**WHITE LAKE TOWNSHIP
INTER-OFFICE MEMORANDUM
COMMUNITY DEVELOPMENT DEPARTMENT**

**SUBJECT: Panera
Preliminary site plan approval**
Property described as parcel number 12-20-276-035, located north of Highland Road (M-59), west of Bogie Lake Road, southeast of Meijer consisting of approximately 1.63 acres.

RE: Panera Bread and Retail Development- Preliminary Site Plan Review – 3rd Review

RE: Panera Bread
Preliminary Site Plan – Review #3

Project Number:	Sheet Number:
230094	A201
Drawn By:	CAO
Issue Date:	XX.XX.XX
DPM:	DM: CPM:
DPM	DM CPM

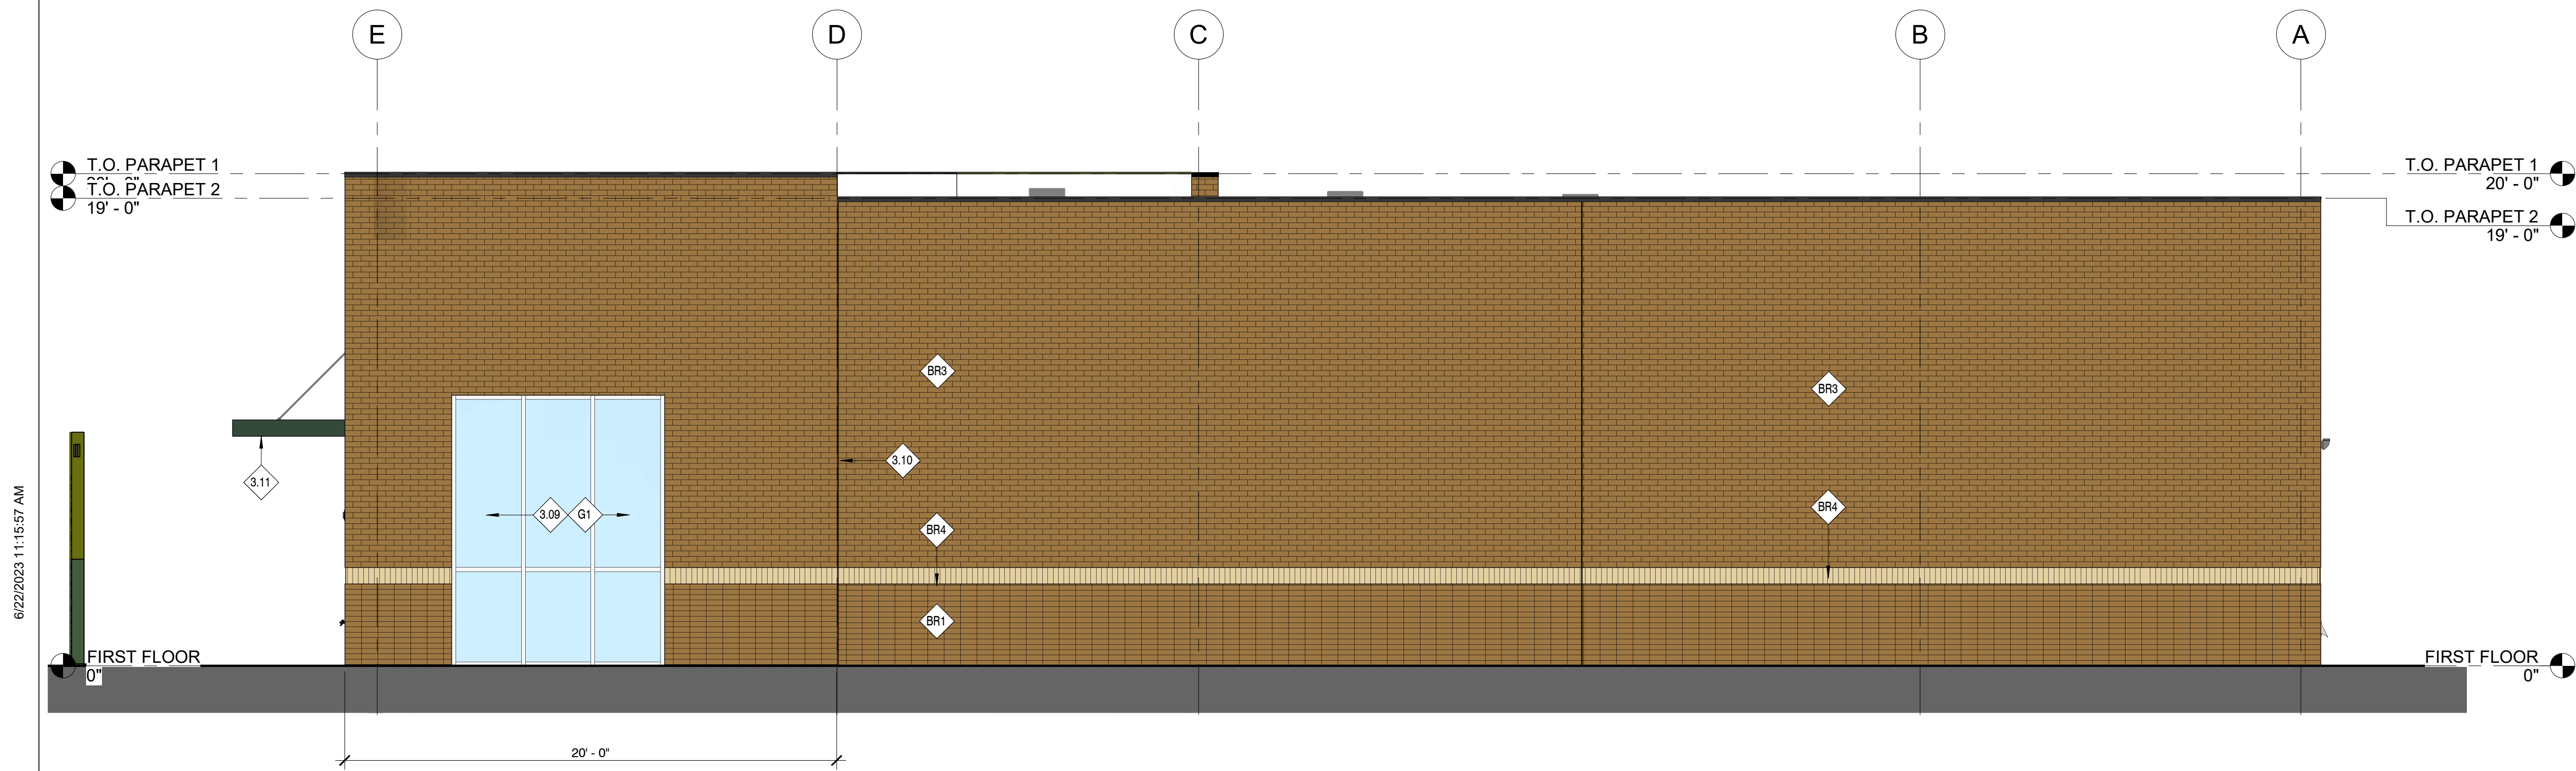
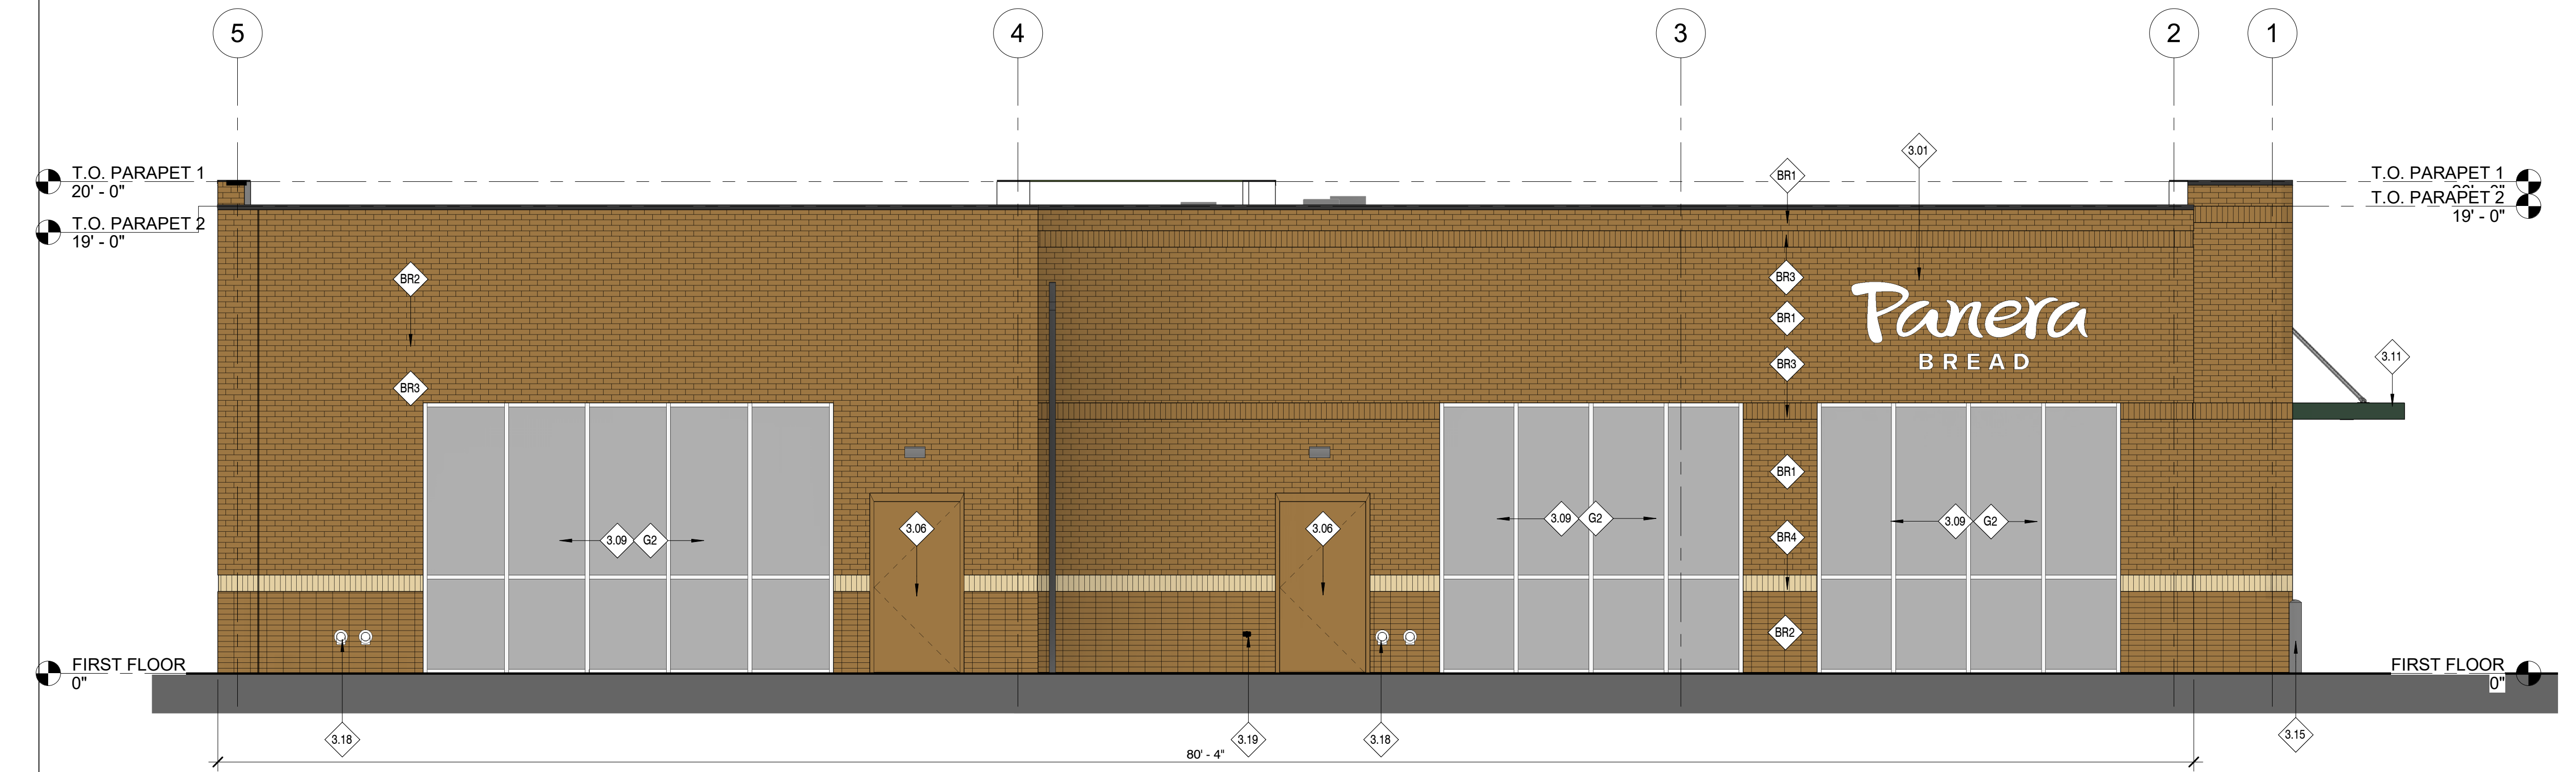
All buildings shall have windows at eye level covering at least 30 percent of the front facade (north and south elevations of the building). The building elevations shall be revised to provide the required windows, and a window coverage calculation shall be provided on the building elevations. (Comments addressed. The north and south facades now contain the required window coverage, and such coverage has been noted on the exterior elevations).

Sheets A200, A201, and A101 reference sheets not provided in the plan set – provide the referenced sheets or remove references to sheets not provided. (Comment addressed. References to sheets not provided in the plan set have been removed).
